# DEVIATION REQUEST AND DECISION FORM

Project Name : Mayberry Phase 1  
Schedule No.(s) : SF2219 (Filing 3)  
Legal Description : N1/2 of Sect 14, Township 14 S, Range 63 W of 6<sup>th</sup> P.M., El Paso County, Colorado

A deviation from the standards of or in **Section 2.3, Table 2-7, Footnote 3** of the Engineering Criteria Manual (ECM) is requested.

50' ROW - LOT ACCESS FRONTAGE  
1" = 5'

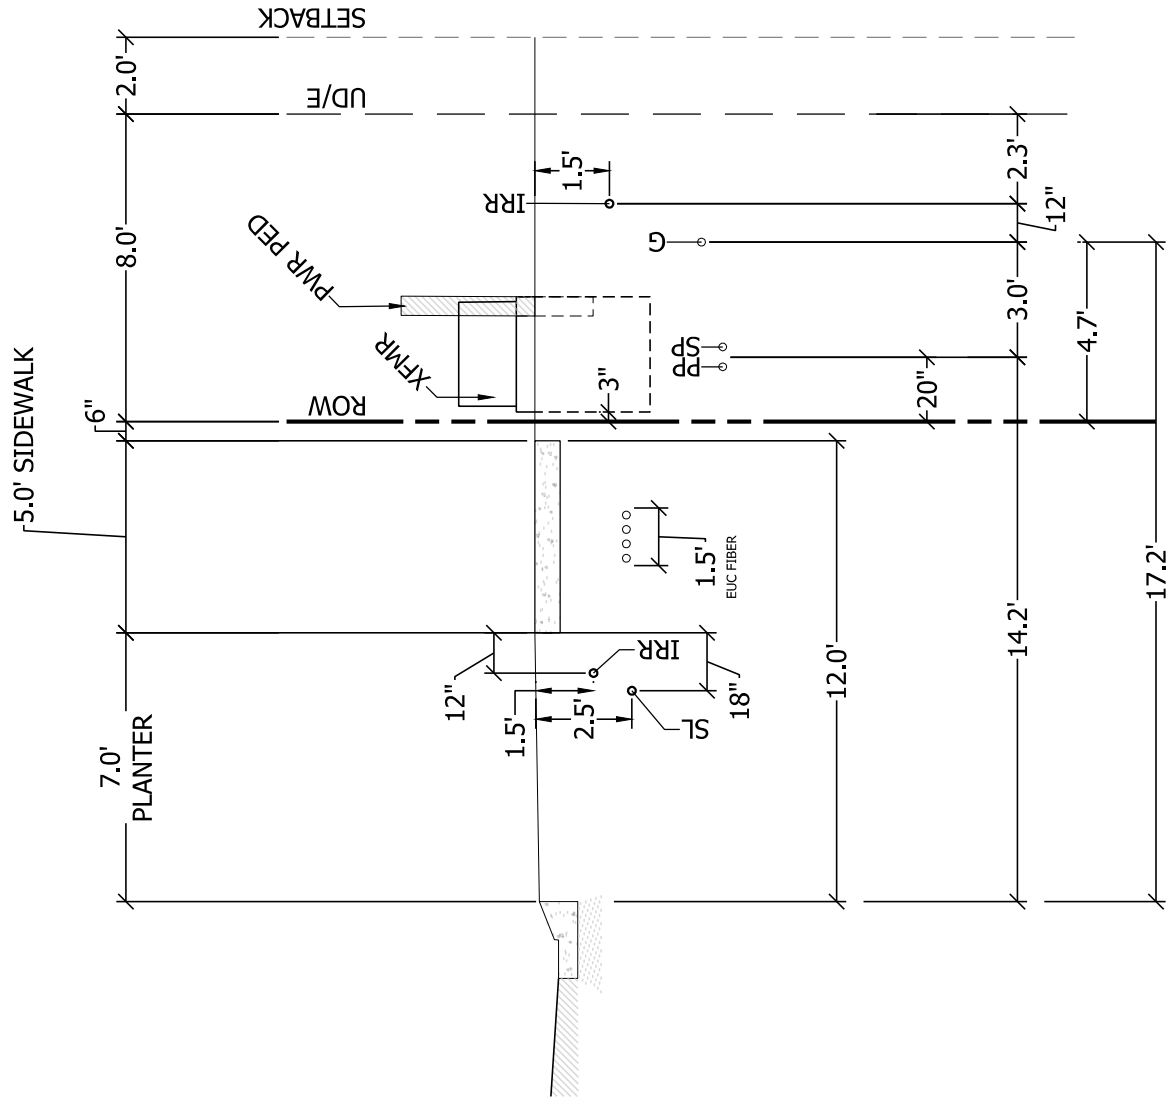
Discussions with EPC engineering staff indicate the purpose of the PIE is to ensure adequate space is available to remove and replace sidewalk in the future. Mayberry Filing 3 specifies two different sidewalk orientations, detached (60' ROW) and attached (50' ROW). In the detached configuration, the 5' sidewalk is separated from the curb by 7' and from the ROW by 6". In the attached configuration, the 5' sidewalk is located tight to the curb and is separated from the ROW by 2.5'. See attached exhibit for illustrations of the typical sections.

Mayberry Communities believes adequate space is available within the ROW for both the attached and detached configurations to adequately maintain the sidewalk. Therefore, Mayberry Communities requests to deviate the standard by allowing for the omission of the PIE in all cases within Filing 3.

**Approved by the ECM Administrator**

<p><b>Approved</b> by Jeff Rice El Paso County Department of Public Works on behalf of Elizabeth Nijkamp, Deputy County Engineer</p>  <p>06/14/2023 10:04:52 AM</p>
--
